APPLICATION OF TEXAS UTILITIES
GENERATING COMPANY, ET AL. FOR
AN OPERATING LICENSE FOR
COMANCHE PEAK STEAM ELECTRIC
STATION UNITS #1 AND #2
(CPSES)

Docket Nos. 50-445
and 50-446

TESTIMONY OF CASE WITNESS
MARK A. WALSH

FIGURE 3.7B-1

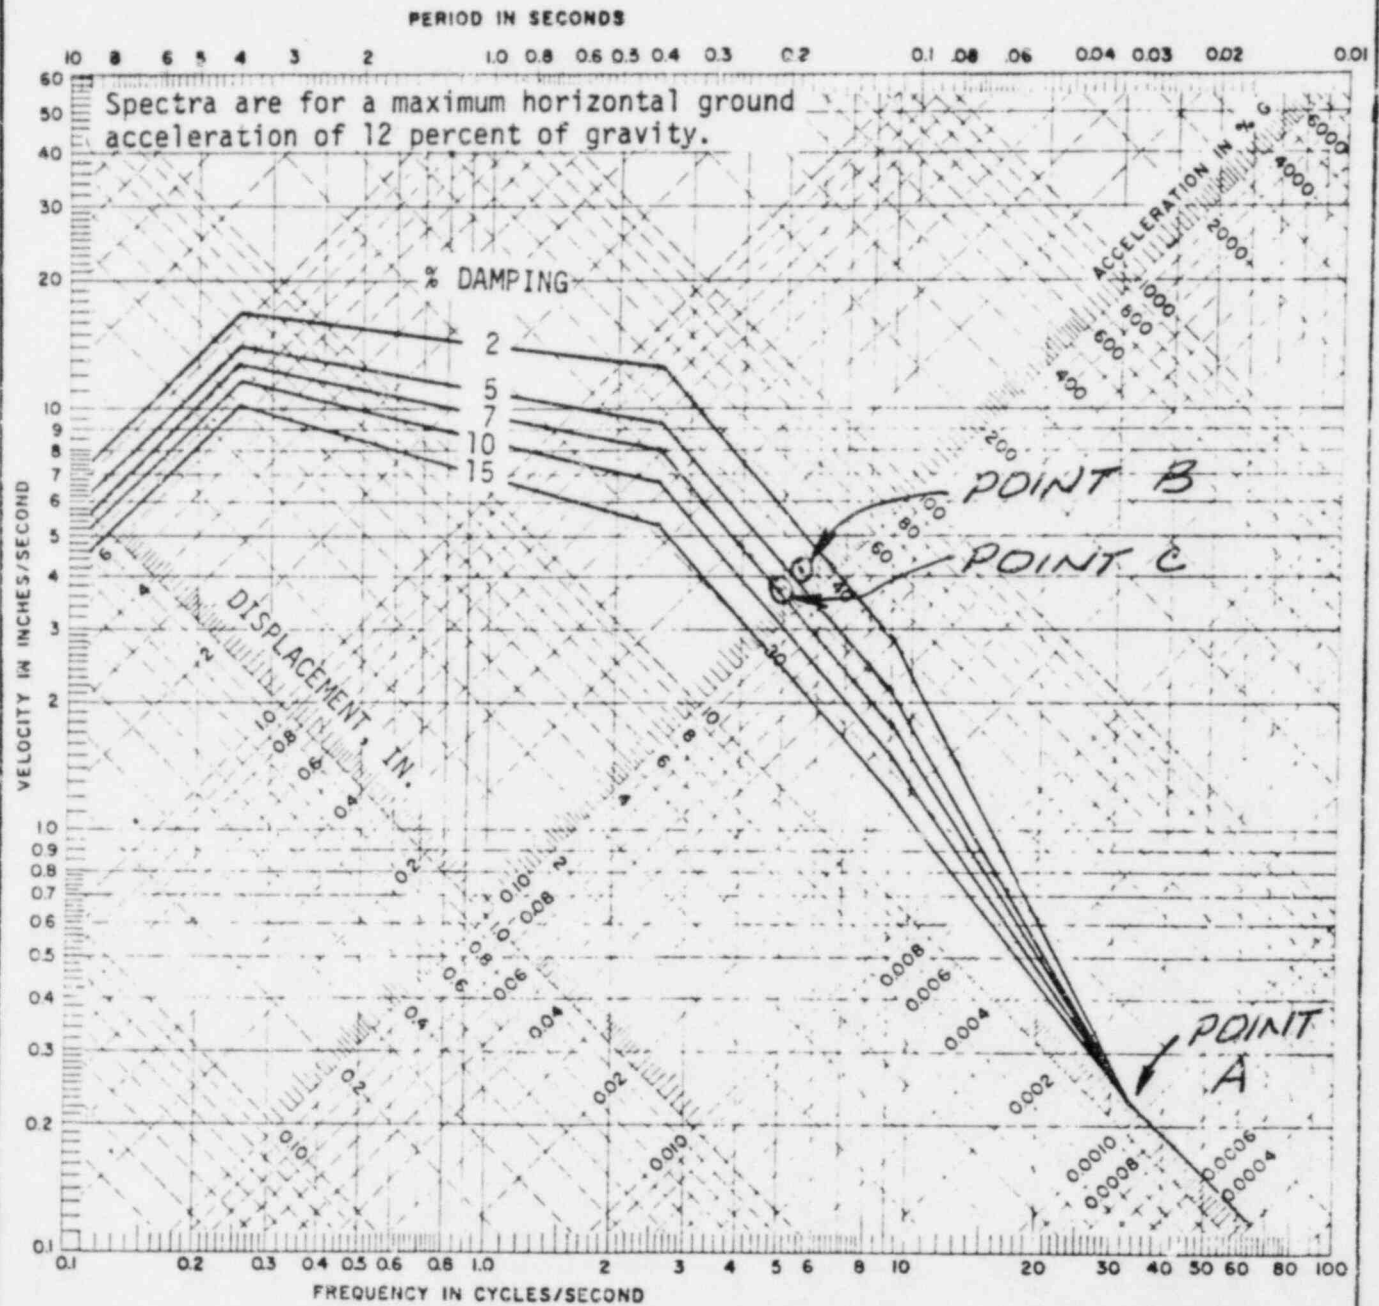
14 Figure 3.7B-1 from Applicants' FSAR (Applicants' Exhibit 3), copy attached
15 as Attachment A hereto, is a response spectra curve of the SSE, located at
16 the ground elevation. Elevations higher than the ground elevation will exhibit
17 higher accelerations. The type of structure (i.e., concrete or steel) will
18 also play an important part in the accelerations at different elevation within
19 the building. Since the response spectra curve shown in Figure 3.7B-1 is
20 for ground acceleration, an item completely rigid will exhibit the same ac-
21 celeration as the ground, and for the response spectra curve, the value is
22 12% of gravity. An item can be considered rigid when its natural frequency
23 is 33% as shown as what I have indicated as Point A (see Attachment A).
24 One will note, damping plays no part in the acceleration when a support is
25 rigid. Note also, the displacement for a rigid support is less than .0015

2 The load which causes the displacement is from the weight of the support
3 and the tray with its contents. The weight is in the horizontal direction
4 and is actually the mass times the acceleration due to gravity that is contri-
5 buting to the horizontal displacement. When a support is rigid, the seismic
6 acceleration it will experience is .12 g's at ground level, and this is in-
7 dependent of damping.

8 Now consider a support that displaces 1/8 of an inch (.125 inches) using
9 4% damping its horizontal acceleration at ground level is 35% of gravity, as
10 indicated on Attachment A as point B. With 7% damping, its horizontal accelera-
11 tion would be 28% of gravity. It is apparent that the higher damping will
12 produce smaller seismic loads. But equally apparent is the acceleration
13 from a rigid condition equalling 12% of gravity goes to 28% of gravity with 7%
14 damping, in essence the seismic load will double.

15 As has been demonstrated above, a 1/8 inch displacement makes a significant
16 difference on seismic loads. CYGNA's comment "Plate slippage will increase
17 damping and thereby lower applied seismic loads" is unfounded. Although the
18 Applicants may have increased the dead weight by 17.5% on some frames, this
19 is quickly offset by the exclusion of the frames' self weight excitation and
20 the neglect to consider the effects of oversized holes as well as the other
21 items not included in the original analysis.
